Service Bulletin

Bulletin No. 2015-06
OEM No. 2015-05

Official Recall Notification U.S. Federal Boat Safety Act: #6 Fuel Injector and Water-Separating Fuel Filter Require Inspections

4.5L Sterndrive Engines

#6 Fuel Injector

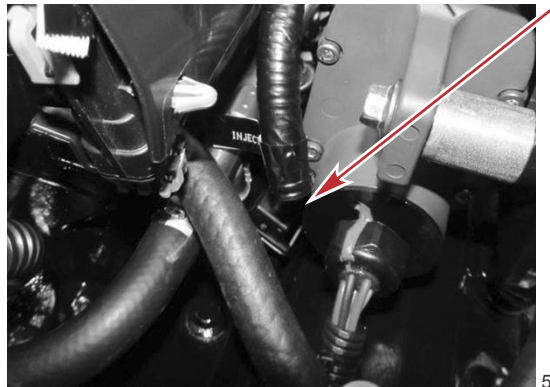
Inspect for a blue dot on the number 6 fuel injector connector. If the dot is present, the inspection has been completed. If the dot is not present, perform the following procedure:

1. Visually inspect DTS units to ensure that the injector connector is free and not bound by the actuator housing. The injector should rotate freely from the 6 o'clock position to the 8 o'clock position.

NOTE: The 6 o'clock position is defined as perpendicular to the fuel rail, with the 9 o'clock position being parallel to the rail. The 8 o'clock position is therefore at a 30° angle to the fuel rail.

58802

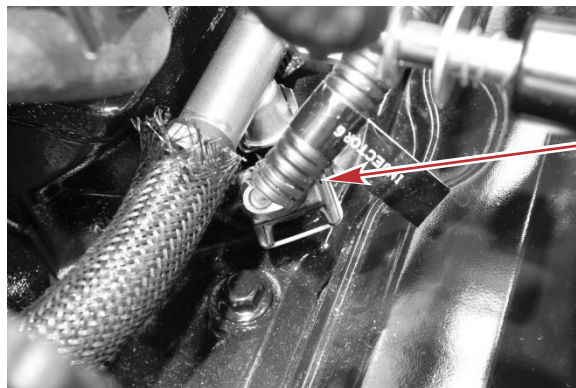
With the injector connector at the 6 o'clock position, it can bind against the actuator housing. Ensure that it is free to turn to the 8 o'clock position.

2. If the injector is found to be bound, loosen the shift bracket assembly from the exhaust manifold and reorient (rotate) the fuel injector to the 8 o'clock position.

3. Tighten the fasteners for the shift bracket assembly to the specified torque.

Description	Nm	lb-in.	lb-ft
Shift bracket assembly fasteners	11.5	102	–

Fuel inlet with quick-connect fitting

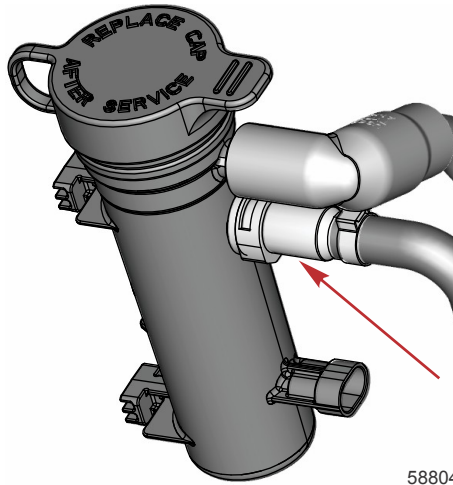
Inspect the water-separating fuel filter housing inlet fuel line connection for wetting or leaks. The fuel line is attached via a quick-connect fitting, which allows easy removal if further investigation is needed.

If the boat has not yet been fueled and run, then this leak check should be done as part of the pre-delivery inspection (PDI).

Torque sequence for oil line retainer fasteners at the oil filter

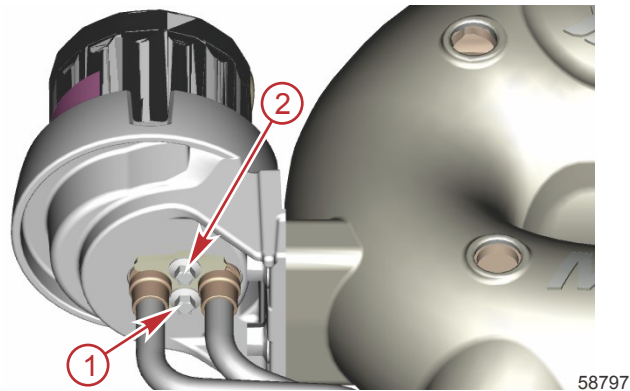
Inspect the oil line retainer fastener heads for blue paint dots. If the dots are present, then the retorquing procedure has been completed. If the dots are not present, complete the following:

Tighten the fasteners on the oil line retainers at the remote filter base and cylinder block locations to the specified torque, following the indicated torque sequence.

Description		Nm	lb-in.	lb-ft
Oil line retainer fasteners	First Pass	13	115	–
	Final Pass	13	115	–

Port side shown, starboard similar

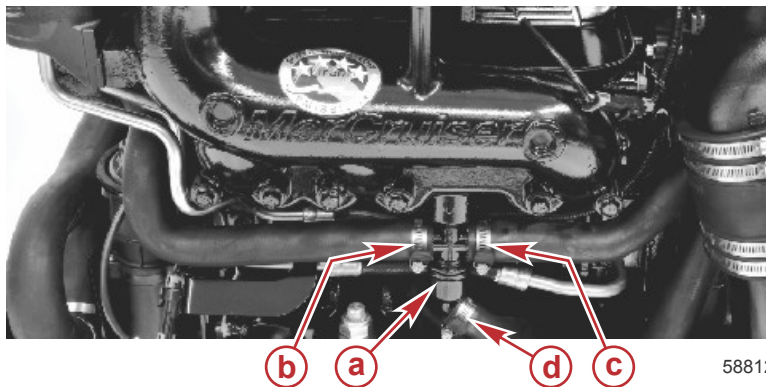
Inspect the drain valves for green paint dots on the side of the plastic drain fittings. If the dots are present, the valve replacement has been completed. If the dots are not present, replace the drain check valves (two per engine, on the bottom side of the exhaust manifolds) as follows:

1. Drain the seawater from the manifolds. Refer to the appropriate procedure in the **4.5L Mercury MerCruiser Service Manual**.
 - For Bravo models, refer to **Air Actuated Single-Point Drain System—Bravo Seawater Cooling**.
 - For Alpha models, refer to **Manual Single-Point Drain System—Alpha Seawater Cooling**.
2. Disconnect the three hoses from the drain valve assemblies. Retain the hose clamps and hose clamp covers.

- a - Drain valve assembly
- b - Seawater cooling hose - disconnect
- c - Seawater cooling hose - disconnect
- d - Seawater drain hose - disconnect

3. Remove the drain valve assemblies from the exhaust manifolds. Discard the drain valve assemblies.
4. Install new drain valve assemblies into each manifold by turning them until they are hand-tight. Tighten the assemblies an additional 2-1/2 to 3-1/2 turns. The assemblies should be parallel to the manifold, and the drain (bottom plastic fitting) should angle toward the rear of the engine.
5. Attach the three hoses to each of the drain valve assemblies and secure them with hose clamps. Tighten the hose clamps to the specified torque. Install the retained hose clamp covers onto the hose clamps.

Description	Nm	lb-in.	lb-ft
Hose clamps	4.5	39.8	–

Kink in PCV hose

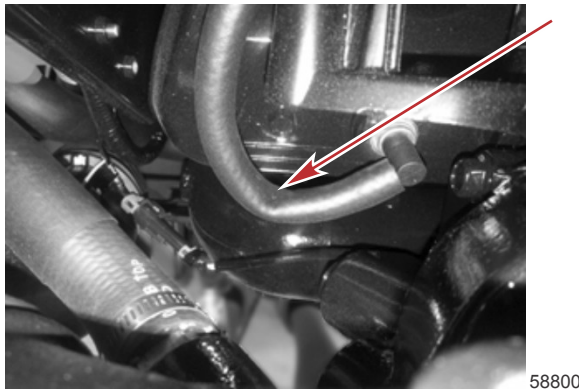
2. Inspect the PCV hose for kinks that restrict proper ventilation.

3. If a kink is found, remove the hose from the PCV valve, and reduce the length such that it reaches the valve but does not kink.
4. Reinstall the hose.
5. Install the outside engine cover.
